**TUS Moylish to City Active Travel
Scheme**

Stage 1 Road Safety Audit

Document Ref: P21-103-RSA-PD-RP-001

Location: General – Raised Table at Side Roads

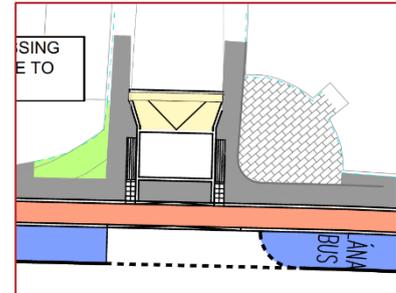
Summary: Hazard tactile paving has been indicated at the edge of the footpath at raised table junctions which may lead to confusion for visually impaired pedestrians.

A raised table has been indicated at the majority of side road junctions within the proposed Scheme with the footpath indicated continuing across the top of the table and a ramp rising from the side road carriageway to tie into the raised table.

Corduroy hazard tactile paving has been indicated at the edge of the footpath on both sides of the side road adjacent the ramp. The Audit Team are concerned that the use of this type of paving in this location could mislead visually impaired pedestrians, into mistaking the raised table for a series of steps, resulting in unsafe entry to the side road carriageway and an increased risk of being struck by a vehicle.

The corduroy hazard tactile paving should be omitted.

Location: General – Crossings of cycle track at island bus stops

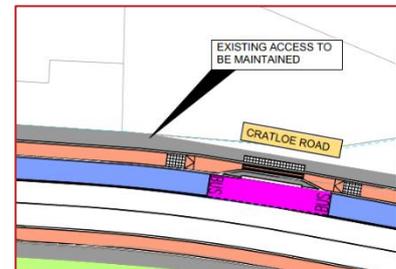
Summary: The proposed layout at the crossings of the cycle tracks at a number of bus stops within the Scheme may lead to an increased risk in collisions involving cyclists and pedestrians.

Island bus stops have been indicated on Cratloe Road throughout the proposed Scheme. A pedestrian crossing of the cycle track has also been indicated at these locations for pedestrians to travel between the footpath and floating island bus stops. The proposed layout at the bus stops may lead to an increased risk of pedestrian-cyclist collisions, or loss of control collisions for cyclists, due to the following: -

- The width of the island is relatively narrow and it may not accommodate the volume of pedestrians waiting at the bus stop which may lead to waiting pedestrians encroaching into the cycle track, and blocking the path of a cyclist.
- The cycle track through the bus stop is relatively narrow through the crossing and, in some locations, includes sharp changes in direction, and tight radii, within the horizontal alignment upstream and downstream of the crossing.
- The tactile paving suggests that these will be uncontrolled pedestrian crossings. Visually impaired pedestrians would be unable to safely, and independently, navigate these type of crossings and would therefore be unable to travel between the floating island and footpath.
- No tactile paving indicated within the bus stop islands to advise visually impaired passengers who disembark at the stop of the cycle lane/track.

At all island bus stop locations, a continuous footpath connection should be provided between the footpath and the bus stop island. The island should be of adequate width (e.g. the National Cycle Manual recommends a minimum island width of 3m) to accommodate the expected volumes of waiting passengers.

Upstream of the link between the footpath and island, the cycle track should be terminated with cyclists required to give way to pedestrians on the footpath connection, with the cycle track commencing again downstream. Ladder & tramline tactile paving will be required at this crossing point. Alternatively, the National Cycle Manual In-line Bus-stop Option 3 could be used instead.

The horizontal alignment of the cycle track should not include any sharp changes in direction or tight radii.

Location: General – Vehicular Accesses

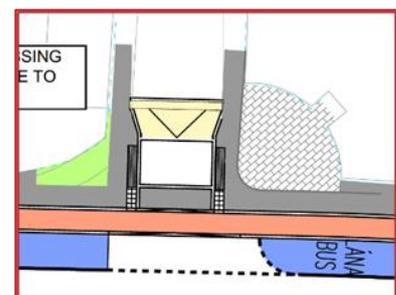
Summary: The layout at vehicular accesses within the Scheme, where drivers are required to cross the footpath and cycle track, has not been indicated.

There are a number of existing vehicular accesses on both sides of Cratloe Road, for example at residential properties and at the Thomond Park Stadium, with some residential properties located in close proximity to each other, which would require drivers to cross the footpath and cycle track when entering/exiting these accesses. The proposed layout of these accesses has not been indicated and it is unclear how drivers will cross the raised cycle track, and subsequently the footpath, at these locations which may lead to material damage as vehicles travel over the raised kerbs.

Also, if it is required to lower and raise the footpath/cycle track, at residential properties there is a risk of discomfort for cyclists.

This is a particular concern for drivers of powered two-wheelers who may experience greater difficulty in traversing raised kerbs increasing the risk of loss of control collisions.

As the design progresses, a layout, which is safe for all road users, should be provided at vehicular accesses which require drivers to cross the footpath and cycle track.

Location: General – Throughout the Scheme

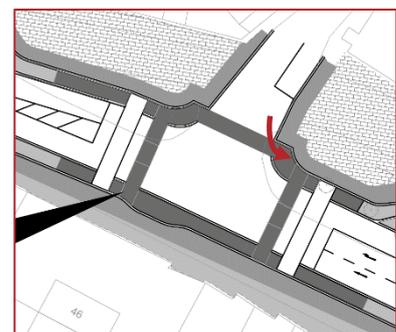
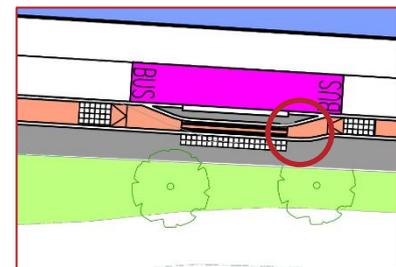
Summary: The amended alignment of roads within the proposed Scheme result in a number of sudden changes in the kerb line which may lead to an increased risk of kerb strikes.

The provision of segregated cycle tracks on Cratloe Road and adjoining side roads within the Scheme results in amendments to the existing, and the provision of new, kerb lines.

The amended alignment of the roads within the Scheme, due to the new kerb lines, results in a number of locations where there are sudden, sharp, changes in direction of the kerb, which may lead to an increased risk of kerb strikes and material damage or loss of control type incidents and secondary collisions with other road users or items of roadside furniture.

The new, and revised, kerb line alignment should include smooth transitions at changes of direction in the horizontal alignment such that drivers are gradually guided through any change in direction, thus mitigating the potential for kerb strikes.

Location: General – Cycle track throughout the Scheme

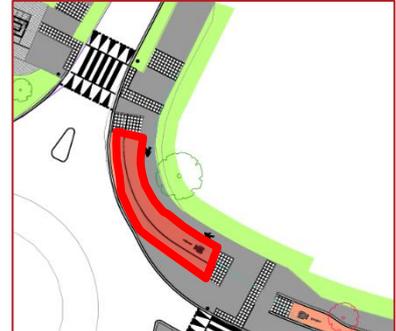
Summary: Sharp changes in the cycle track alignment, combined with tight radius curves, may lead to an increased risk of loss of control type incidents.

There are some locations within the proposed cycle tracks throughout the Scheme that include sudden changes in the horizontal alignment, combined with short radius curves, including locations where cyclists turn left onto the cycle track at signalised junctions from side roads which do not provide segregated facilities, as this manoeuvre is likely to require cyclists to turn through 90°.

The combination of short radius curves and changes in direction could lead to cyclists, who are likely to approach these locations at higher speeds from relatively straight sections upstream, losing control of, and falling from their bicycle, resulting in personal injuries.

A more forgiving horizontal alignment should be provided within the cycle track with no sharp changes in direction or tight horizontal radii, ensuring cyclists can safely travel through horizontal curves within the cycle track alignment and can safely access/transition to the cycle track/lanes from adjacent side roads.

Location: Drawings 19-003-LCCC-CR-S2-0002 (Rev. P0.07) & 19-003-LCCC-CR-S2-0004 (Rev. P0.13)

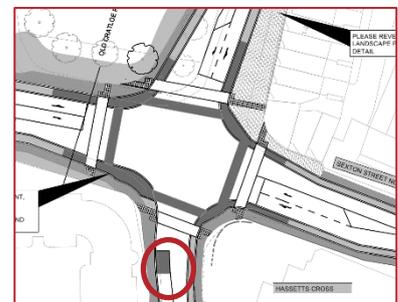
Summary: The width of the pedestrian crossings at signalised junctions may be too narrow to accommodate the expected volumes of pedestrians.

The widths of the proposed pedestrian crossings at signalised junctions within the Scheme appear to be quite narrow and may not sufficiently accommodate the volume of pedestrians at this location.

The width of the pedestrian crossings at signalised junctions within the Scheme should be increased in accordance with the DMURS which recommends a minimum width of 4m for pedestrian crossings in busy urban areas.

Location: Drawing 19-003-LCCC-CR-S2-0002 (Rev. P0.07)

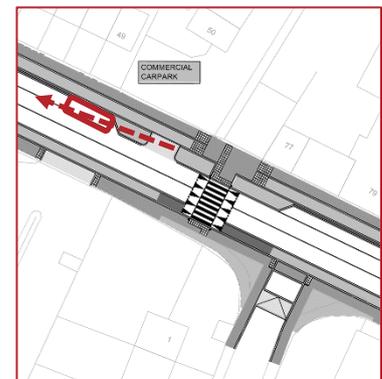
Summary: The straight-ahead eastbound traffic lane on Cratloe Road becomes the right-turn only lane immediately upstream of the junction with Shelbourne Road & Kileely Road and drivers may be insufficiently aware of need to change lane to continue eastbound.

The eastbound traffic lane on Cratloe Road develops into the right-turn lane at its junction with Shelbourne Road & Kileely Road with the bus lane terminating upstream of the junction to allow straight-ahead and left-turn movements from the nearside lane. Drivers in the eastbound lane, wishing to continue straight through the junction, may be insufficiently aware of the need to change lane on approach to the junction leading to sudden lane changing manoeuvres upstream of the junction resulting in side swipe collisions.

The Audit Team acknowledge that further design is required regarding turning lanes at signalised junctions following traffic modelling however, should the lane configuration indicated be retained, drivers should be clearly advised of the correct lane to enter for their intended destination in good advance of the junction such that they have time to take in the information and undertake safe lane changing manoeuvres upstream of the stop line.

Location: Drawing 19-003-LCCC-CR-S2-0003 (Rev. P0.13)

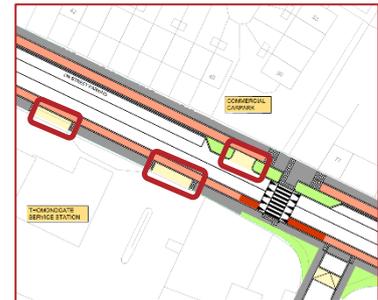
Summary: Visibility to the west for drivers exiting the Commercial Carpark may be restricted by vehicles parked in the on-street parking spaces adjacent the access.

On-street parking has been indicated at some locations on Cratloe Road, including to the west of the access/egress at the Commercial Carpark opposite the Thomondgate Service Station.

Should the on-street parking spaces at this location be occupied there is a risk that a parked vehicle may be located within the visibility splay of a driver exiting the Commercial Carpark. This could lead to an exiting driver's visibility to the west being restricted leading to them exiting onto Cratloe Road when it is unsafe to do so resulting in side-on collisions.

Ensure parked vehicles at this location do not restrict a driver's visibility to the west when exiting the Commercial Carpark. If the parking is determined to be within an exiting driver's visibility splay the section of parking within the visibility splay should be omitted.

Location: Drawing 19-003-LCCC-CR-S2-0003 (Rev. P0.13)

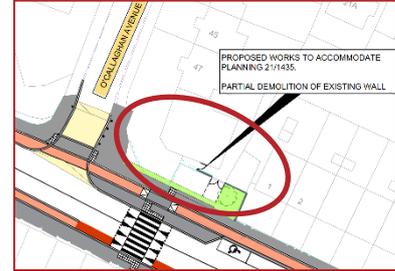
Summary: Raised tables have been indicated at the accesses to the Commercial Carpark and Thomondgate Service Station however no ramp has been indicated on the drawing at these locations and it is therefore unclear how the carriageway will transition to the raised table and if all vehicles will be able to safely traverse the level difference.

Raised tables have been indicated at the accesses to the Commercial Carpark and the Thomondgate Service Station on the northern and southern sides of Cratloe Road respectively to the west of the side road junction with Stenson Park. Ramps have not been indicated at any of these accesses and it is therefore unclear how the carriageway on Cratloe Road, and the internal carriageway within the carpark and service station will tie-into the proposed ramps. If the transition between the ramps and carriageway on either side of the ramps is too sudden there is a risk of drivers having to traverse a steep gradient/level difference which may lead to difficulties particularly for drivers of powered two wheelers.

Additionally, the footpath across all accesses is indicated as discontinuous with priority afforded to vehicles entering/exiting the accesses which is inconsistent with the layout at other side road junctions within the Scheme.

Ensure the gradient, or level difference, between the ramp and carriageway at the accesses can be traversed without difficulty by all road users.

Also, the footpath across the accesses should be continuous with drivers required to give way to pedestrians and cyclists on the footpath and cycle track.

Location: Drawing 19-003-LCCC-CR-S2-0003 (Rev. P0.13)

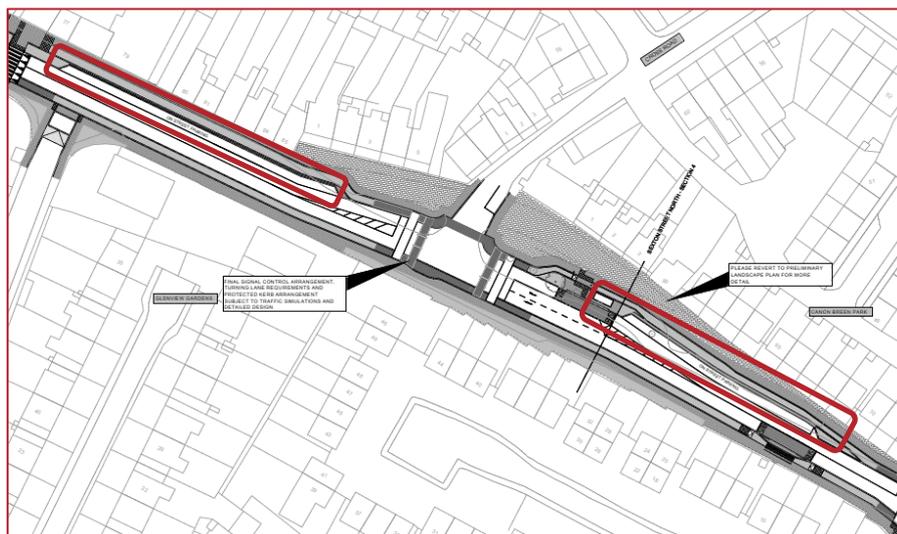
Summary: It is unclear if there will be sufficient space within the site of the existing shop to accommodate the swept path of a delivery vehicle when entering, turning within, and exiting the site.

The existing loading bay on the northern side of Sexton Street North, which is associated with an existing shop premises on the corner of the junction with O'Callaghan Avenue, has been indicated as being removed as part of the proposed Scheme. The Audit Team have been advised that alternative arrangements have been agreed with the shop owner regarding deliveries to the shop, which is proposed to be extended as part of a current planning application. The arrangement will involve delivery vehicles now entering the shop site from the existing vehicular access on O'Callaghan Avenue and unloading items within the extended section of the site, proposed as part of the planning application.

Information regarding the swept path of vehicles using the access (delivery vehicles, refuse vehicles etc.), turning within the site and exiting the access has not been provided, and it is unclear if these vehicles will have sufficient space within the site to turn around, possibly leading to lengthy reversing manoeuvres which can present a hazard to other road users.

The proposed delivery arrangements at the shop, including turning manoeuvres, should be accommodated safely within the proposed new delivery layout.

Location: Drawing 19-003-LCCC-CR-S2-0004 (Rev. P0.13)

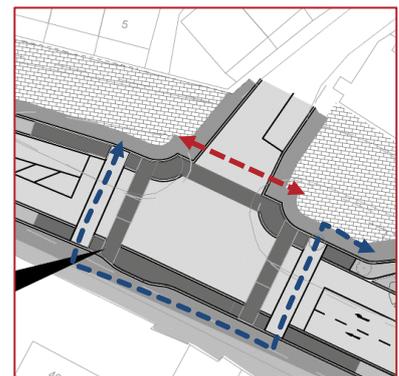
Summary: The combination of the horizontal alignment and on-street parking on Cratloe Road on the eastbound approach to its junction with Cross Road may lead to restricted visibility for a driver towards the traffic signal head(s) at the junction.

There is a change in direction in the horizontal alignment on Cratloe Road upstream of its junction with Cross Road. On-street parking has also been indicated on the northern side of Cratloe Road at this location. Although the location of traffic signal heads at signalised crossings has not been indicated at this early stage in the design, there is a risk that an eastbound driver's forward visibility to the expected location of the primary traffic signal head may be restricted by a combination of the horizontal alignment and the potential for a high-sided vehicle to be parked in the parking space. This could lead to drivers being insufficiently aware of a red signal on approach to the signalised junction resulting in them failing to stop at the stop line and overshooting into the junction where there is a risk of side-on collisions.

Ensure an eastbound driver's forward visibility to the signal heads at the Cratloe Road/Cross Road signalised junction is not restricted. A section of the on-street parking provision upstream of the junction should be omitted if it is found that a parked vehicle may potentially block a driver's forward visibility or cantilever signal supports may be required.

Location: Drawing 19-003-LCCC-CR-S2-0004 (Rev. P0.13)

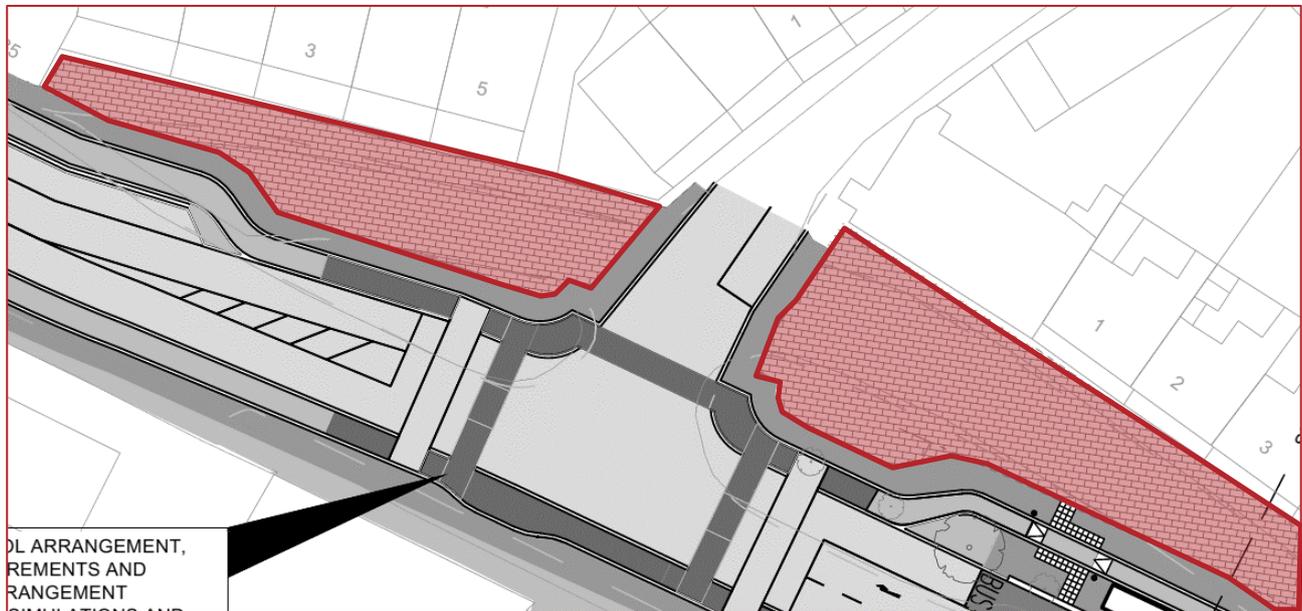
Summary: There is a risk of collisions between vehicles and visually impaired pedestrians within the paved areas in front of the residential properties on both sides of Cross Road at its signalised junction with Cratloe Road.

The existing side roads at Hibernian Villas and An Bóthar Ard, on either side of Cross Road adjacent its junction with Cratloe Road, are proposed to be closed up and paved with a material different to that of the adjacent footpath. These existing roads currently permit access for vehicles to park at the residential properties at these locations. It is unclear if vehicular access will be maintained from Cross Road to these locations to continue to permit residents to park their vehicles here. It is also unclear if these areas will be at the same level as the adjacent footpaths or if a means of segregation/delineation is proposed. If vehicular access is to be maintained to these areas, and sufficient delineation not provided between the footpath and adjacent shared surfaces, there is a risk of visually impaired pedestrians inadvertently entering the shared surfaces where there is an increased risk of being struck by a vehicle.

If vehicular access is to be maintained from Cross Road at these locations a dropped kerb with a minimum upstand of 25mm should be provided at the edge of the footpaths on Cross Road. Additionally, sufficient measures (i.e. level difference) should also be provided between the footpath and adjacent surfaces on Hibernian Villas and An Bóthar Ard such that visually impaired pedestrians are advised of the different surfaces and potential for motorised vehicles to occupy these areas.

Location: Drawing 19-003-LCCC-CR-S2-0005 (Rev. P0.06)

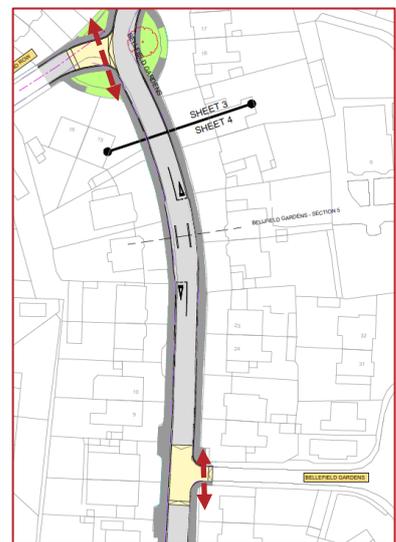
Summary: The islands/kerbs within the carriageway at the give-way layout on Bellefield Gardens may not be sufficiently visible to drivers, particularly during the hours of darkness.

A give-way arrangement has been indicated on Bellefield Gardens which includes narrow islands/kerbs within the carriageway to segregate cyclists and motorised vehicles as they proceed through the reduced cross-section at the chicane.

These kerbs are indicated as having an upstand of 125mm. Drivers approaching the chicane may be insufficiently aware of the kerbs, particularly during the hours of darkness, leading to an increased risk of wheels striking kerbs, or to vehicles with low bodies colliding with the kerbs, resulting in material damage.

Measures should be provided to increase a driver's awareness of the kerbs at the proposed chicane on Bellefield Gardens.

Location: Drawing 19-003-LCCC-CR-S2-0005 (Rev. P0.06)

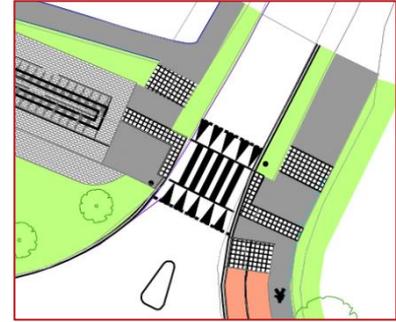
Summary: Pedestrian crossings of side roads on Bellefield Road & Bellefield Gardens have not been indicated.

Pedestrian crossings have not been indicated at the side roads on Bellefield Road and Bellefield Gardens. This could lead to pedestrians crossing side road carriageways at locations where drivers may be less attentive to them increasing the risk of vehicle-pedestrian collisions.

Additionally, a failure to provide crossing points with dropped kerbs may lead to difficulties for mobility impaired pedestrians, particularly wheelchair users, when crossing the carriageway resulting in a risk of trips and falls should they have to descend/ascend full height kerbs.

Pedestrian crossings, including dropped kerbs and associated tactile paving, should be provided at the side roads on Bellefield Road and Bellefield Gardens.

Alternatively, the footpaths should be continuous across the side roads at these locations with 'vehicle crossover' arrangements.

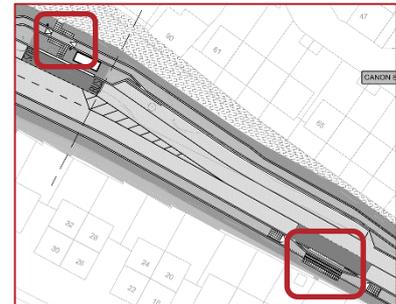
- 4.2 Zebra crossing road markings have not been indicated at crossings of the cycle track where the tactile paving for a controlled crossing has been indicated yet have been indicated at crossings where tactile paving for an uncontrolled crossing is indicated.

This could lead to confusion for visually impaired pedestrians regarding what type of crossing is provided resulting in them being unable to safely and independently navigate the road layout.

Tactile paving at controlled crossings (i.e. Zebra, Pelican, Puffin, Toucan etc.) should be 'L-shaped' and red in colour with the stem located on the right-hand side while tactile paving at uncontrolled pedestrian crossings should be buff in colour and of a sufficient depth for the type of crossing provided (i.e. in-line or inset).

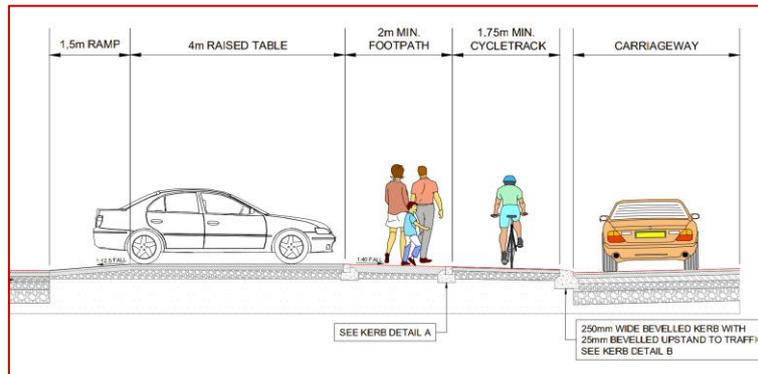
- 4.4 During the Site Visit, the Audit Team noted that the existing footpaths on Bellefield Road and Bellefield Gardens at some locations were in poor condition.

It is assumed that the Scheme will include renewal of the existing footpaths at these locations. A failure to upgrade the footpath at these locations may increase the risk of trips and falls.
